## Reply to Reviewer number 1, Anonymous review

Thank you for your thorough review of our manuscript. Hereby I present the replies to all your comments (in green).

Line 144: “Figure 1”

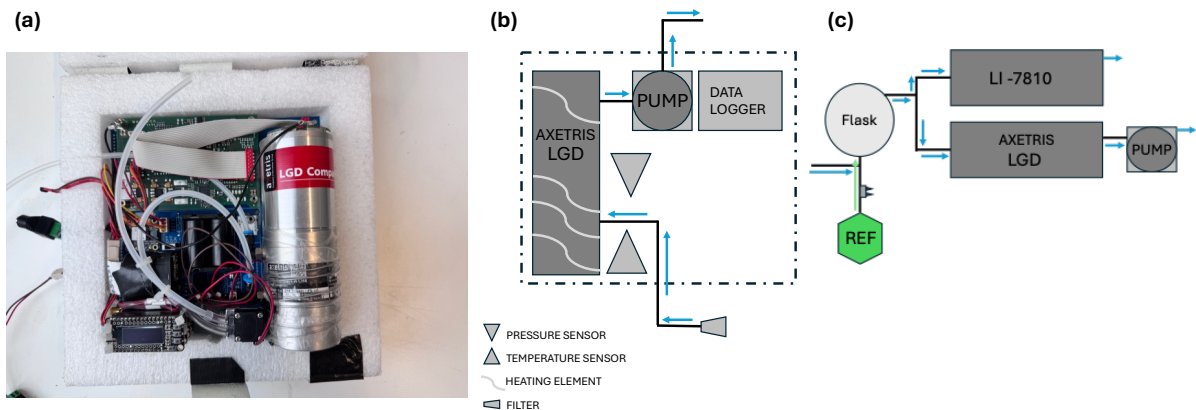
- Consider including an annotated photograph of the sensor package (highlighting the inlet and outlet). This may be included as a subfigure of Figure 1.
  - Revised and added to Figure 1. We decided to leave out the highlighting of the inlet and outlet since this did not make the Figure clearer. Figure one is updated to:

- What does “REF” stand for in this figure? Is it defined in the main text?
  - We added the meaning of REF to the figure caption. The complete caption of Figure 1 now reads: “Figure 1: a) Photograph of the Axetris package. The different colours visualise the flow of air through the sensor. Blue represents the path of the air entering the Axetris sensor. Orange represents the connection between the Axetris and the pump and green represents the outflow of the air. b) schematic overview of the Axetris package for UAS applications. The blue arrows show the airflow through the system during measurements. Components in the dotted and dashed lines enclosed area are integrated onto the PCB and enclosed in the PE foam. The datalogger communicates with the Axetris sensor and provides active control of the heating element, including setting and maintaining the desired temperature. c) Experimental overview for linearity test setup. First, the flask is filled with the reference gas (REF), which has a high CH<sub>4</sub> concentration (indicated by the green arrow). Then, both systems start to sample the air from the flask, while ambient air was drawn in to mix with the high concentration (blue arrows), slowly decreasing the concentration in the flask.”

Line 166: “Linearity of the Axetris”

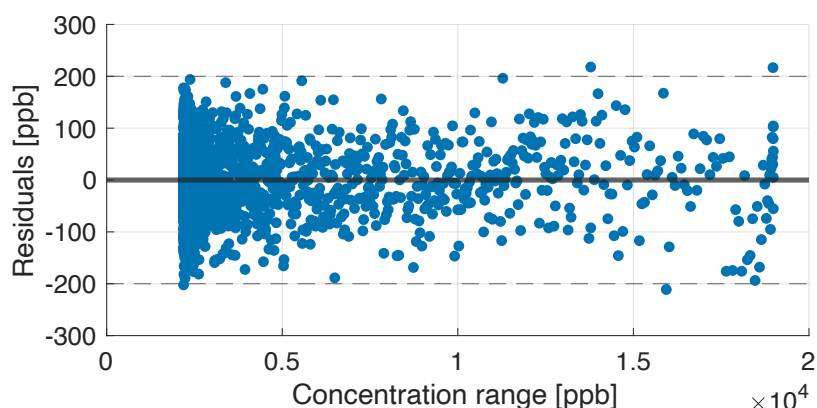
- This subsection (in its current format) does not provide an evaluation of the linearity of the measurement, but rather provides a calibration of the instrument. A linearity test shows whether the increase in one measurement is consistent with increase in a second measurement, following a linear regression. The magnitude of any derived linear coefficients is independent of the standard of linearity.
  - We added a plot of the residuals between observations and the linear fit to show the sensors linearity (i.e., neutral, non-wavey noise around the linear fit) over the observed concentration range. We believe this sufficiently demonstrates the linearity of the Axetris. The following figure is added to the Appendix as Figure B2:

Line 167: “high CH<sub>4</sub> concentration (~81ppm)”

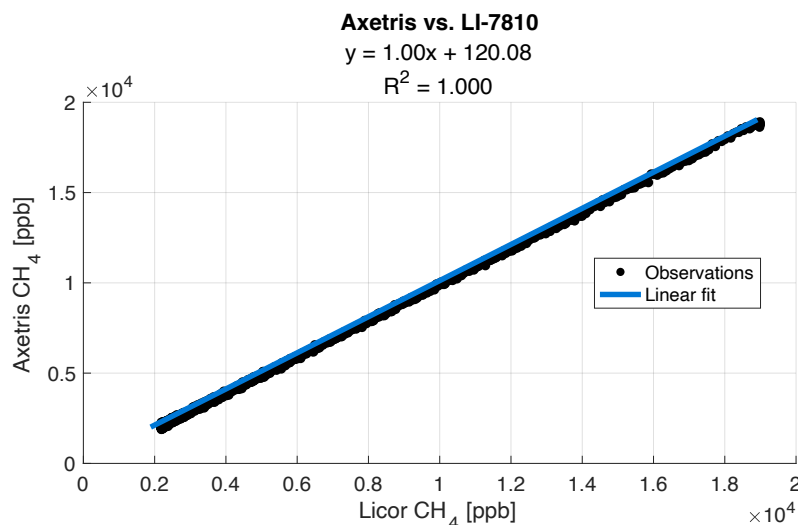
- If this is the case, why is Figure B1 plotted between 0 ppm and 2 ppm? Why not plot it up to 81 ppm?
  - We used 81 ppm to increase [CH<sub>4</sub>] in a mixing vessel to ~21 ppm. Gradual reduction back to background concentrations yields a range from 20 ppm to 2 ppm. For clarity we have removed from the figure the initial (at the start of the experiment) rise from 2 to 21 ppm that, confusingly, was originally visible as a S-shaped trace (due to difference response times of the two sensors). Only the gradual, monotonous decay of concentrations back to ambient is now plotted.
  - The updated Figure (Figure B1) is as follows:

Line 249: “Figure 2”

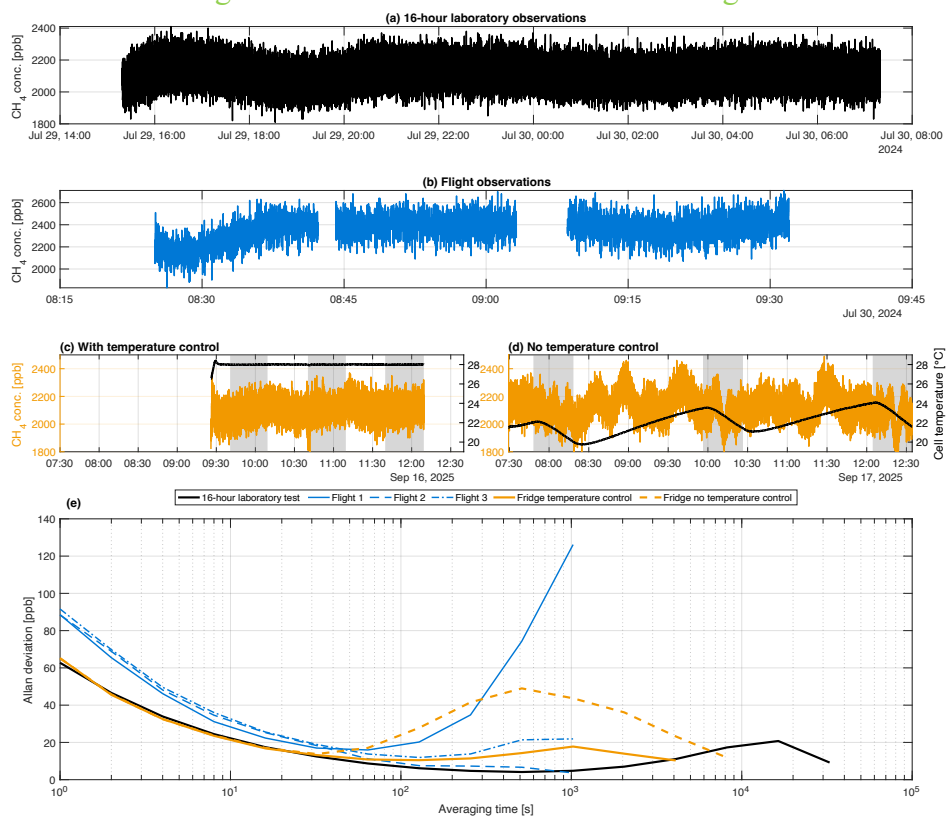
- The title for the horizontal axis title should either be the correct Greek symbol ( $\tau$ ) or be replaced with the text “averaging time”.
  - Revised and changed the xlabel to averaging time.
- It might make more sense to change the colour of subplot b and then to use consistent colours in subplot d. Otherwise it is confusing because different colours mean different things in the four subplots.
  - Revised and changed the colours to match. The revised figure

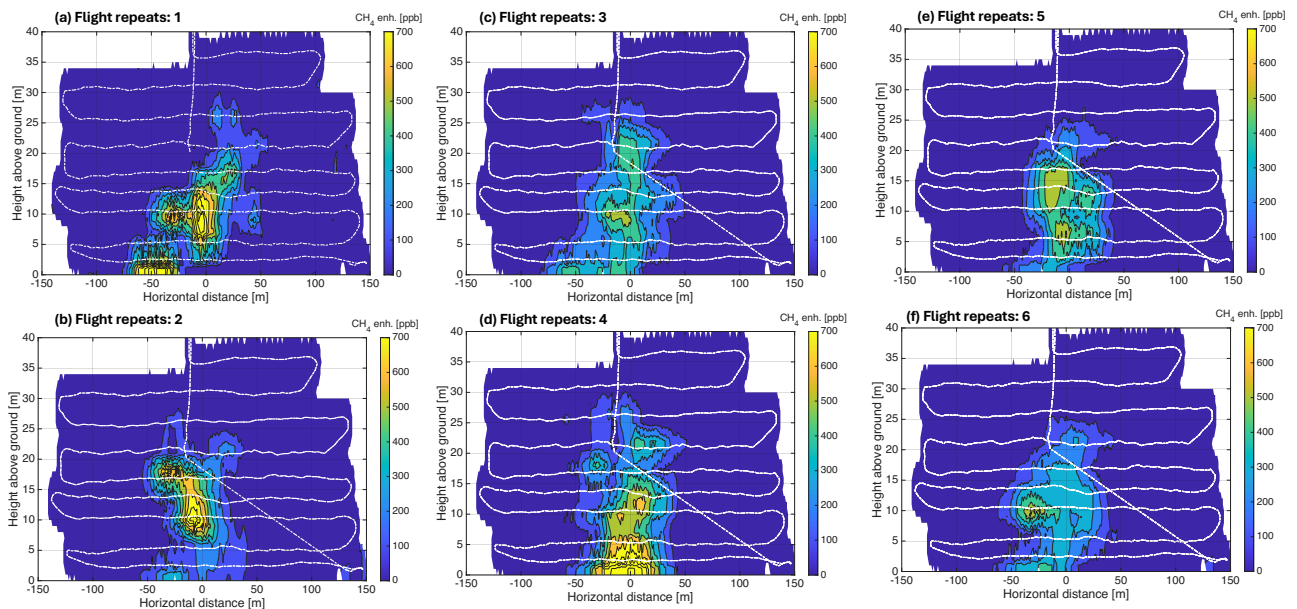
- A fundamental requirement of this approach is the assumption that the emission plume does not move during sampling. This method assumes that turbulence does not change the location of the plume and that the wind direction does not change. Please discuss this here as a caveat to this approach.
  - This is not the case. Turbulence and location variability would yield a broader, more sparse or even non-contiguous and less intense contour plot of identical integral. We acknowledge that this result may not be intuitive. We attempt and clarify and illustrate this in Section 4.2.1: we added a six-panel figure in the Appendix (Figure K2) showing the integral approaching a clean Gaussian after six repeated samplings of the same variable plume.

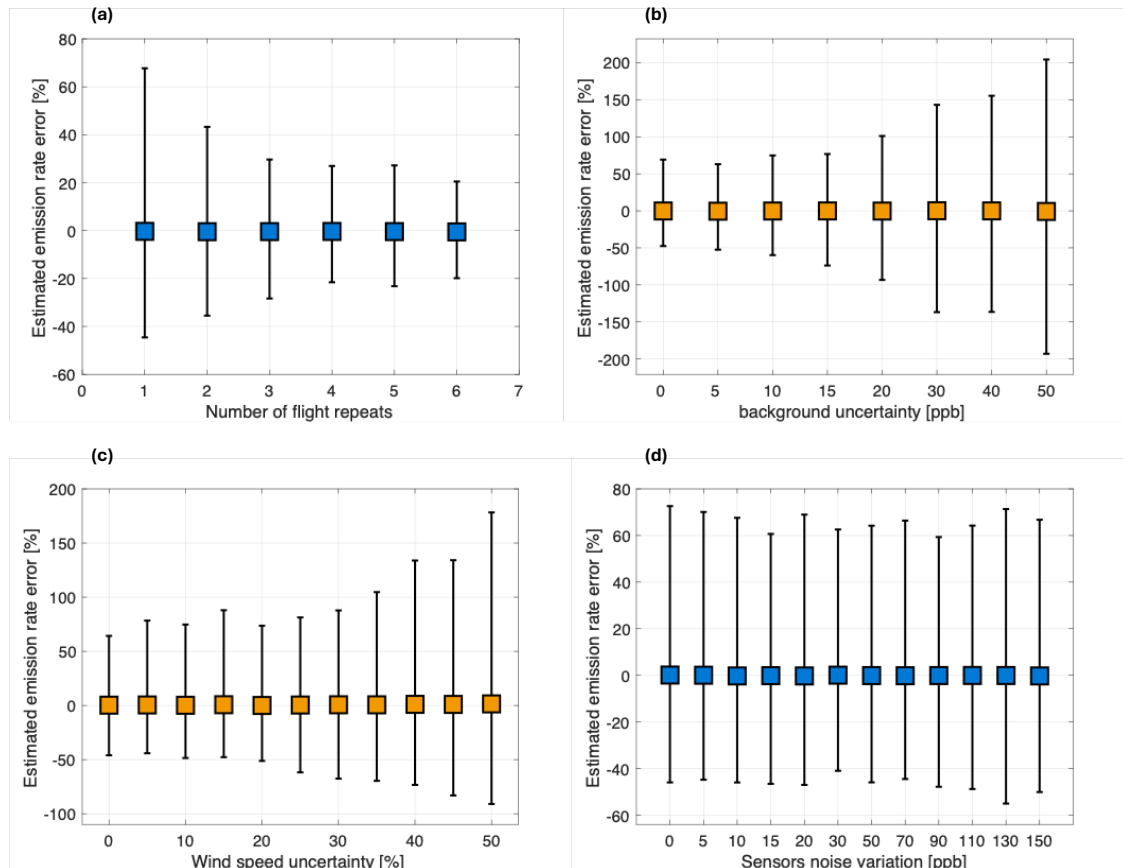
- Why not combine Figure 4 and Figure 5 into a single figure with four subplots?
  - We decided to combine both Figures, resulting in the following Figure and caption:

Line 933: “Figure B1”

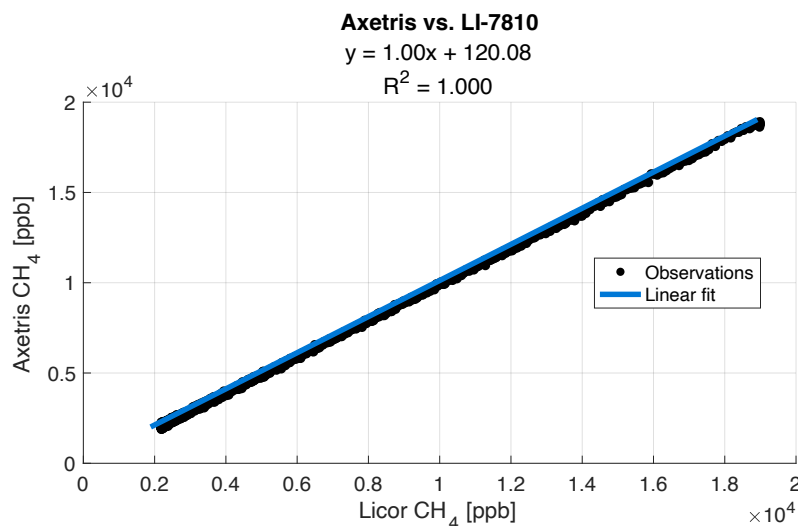
- It is really difficult to distinguish the line from the points. Perhaps make the line bright red with small black dots for data.
  - Revised and changed the line to blue to match the colour scheme of the manuscript
